STAFF REPORT

TO: City Council
FROM: Emily Becker, City Planner
AGENDA ITEM: Easton Village 2nd Addition Final Plat
REVIEWED BY: Stephen Wensman, Planning Director

The City has received a Final Plat application from Chase Development for the 2nd Addition of Easton Village, a 217 unit residential subdivision. The 2nd Addition includes 19 single family lots that are located within 5.2 acres on the eastern portion of the subdivision and extended above the northern boundary of the 1st Addition. Staff and the Planning Commission are recommending approval of the request subject to conditions listed in this report.

SHEET NO.
C3
 SHEET 3 OF 21

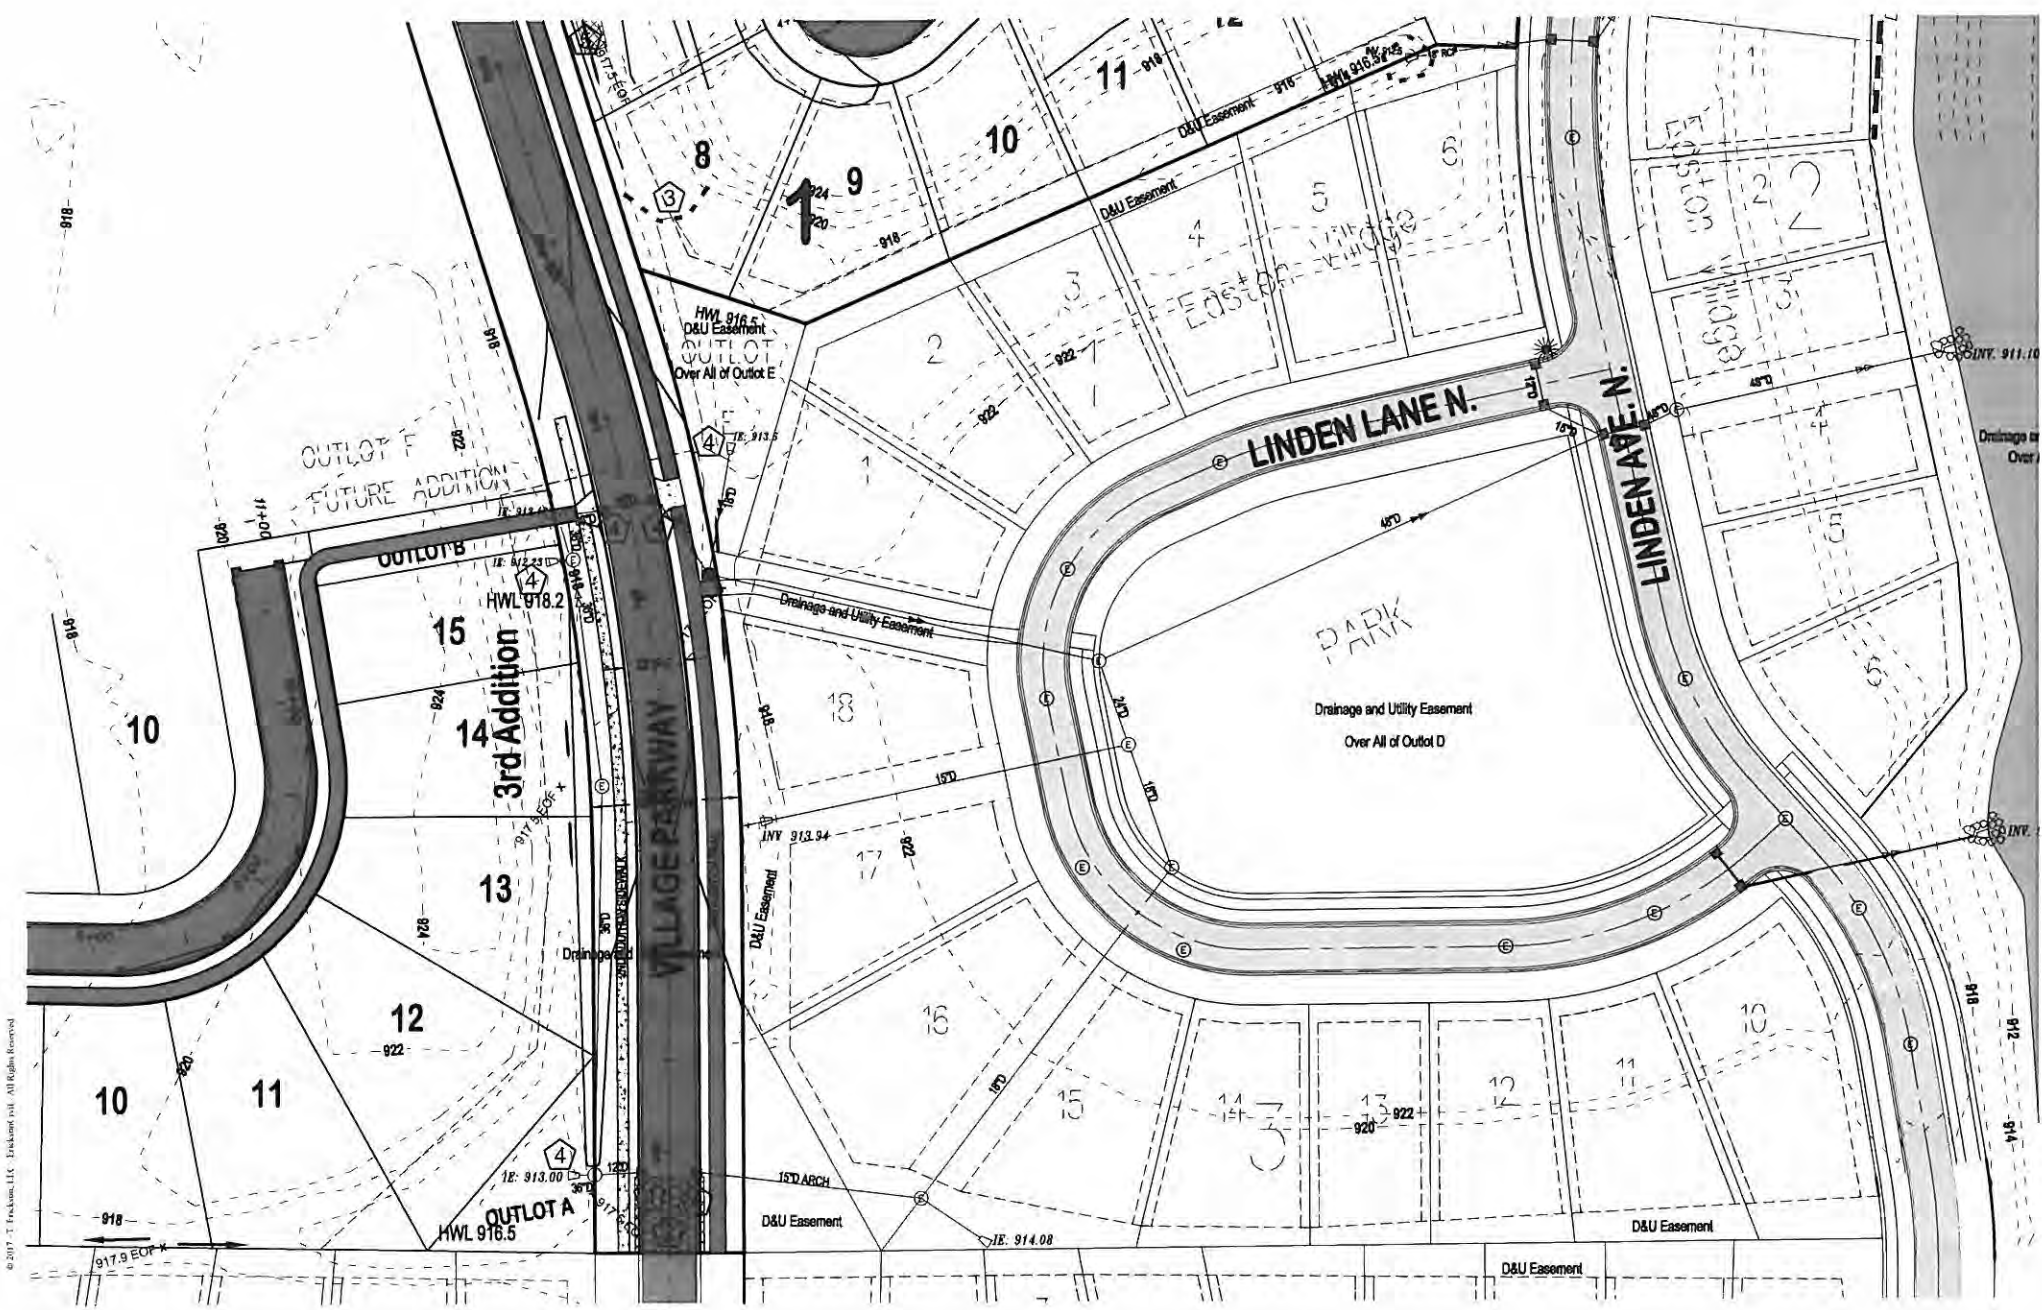
- C3: The first Erosion Control Plan Sheet must have the City Standard Plan Notes for Grading and Erosion Control. Move these plan notes from Sheet C5.

PLAN VIEW - VILLAGE PARKWAY

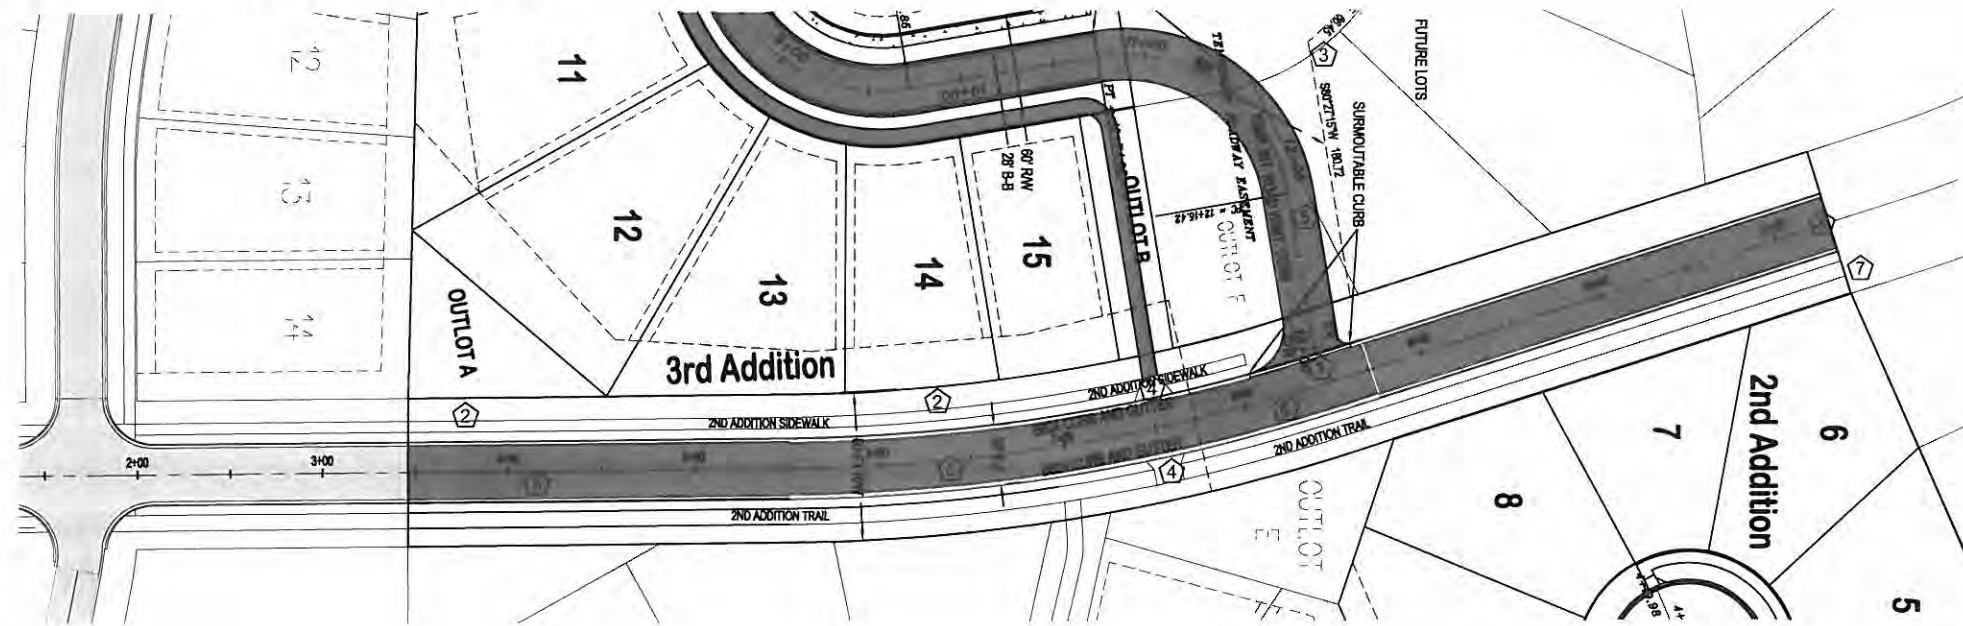
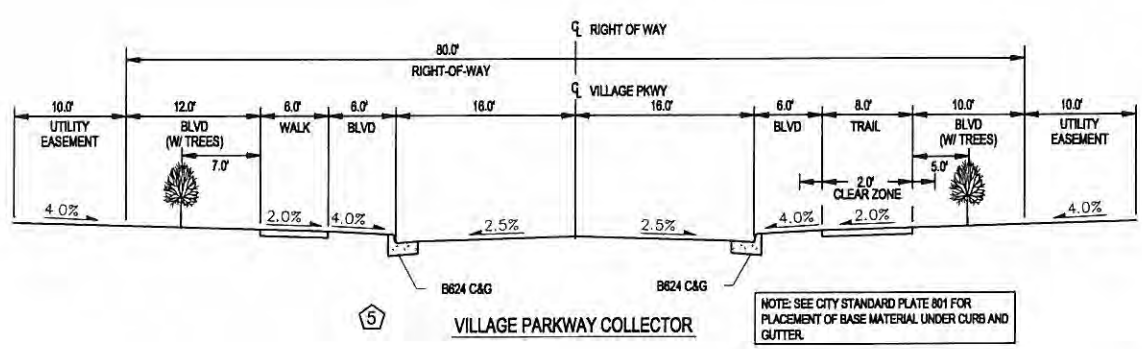
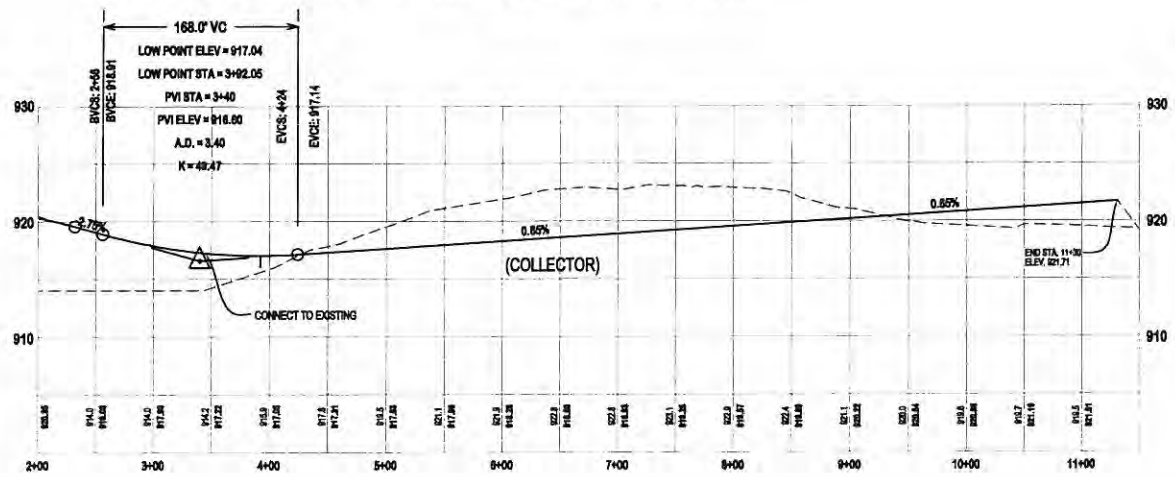
- C11: Revise typical section plan note as follows: "See City standard plate 801 for placement of pavement section including drain tile".
- C11: Add plan notes for completion of Village Parkway storm sewer. Show existing storm sewer as existing on the plans. Add plan notes to adjust catch basins, placement of castings, etc.
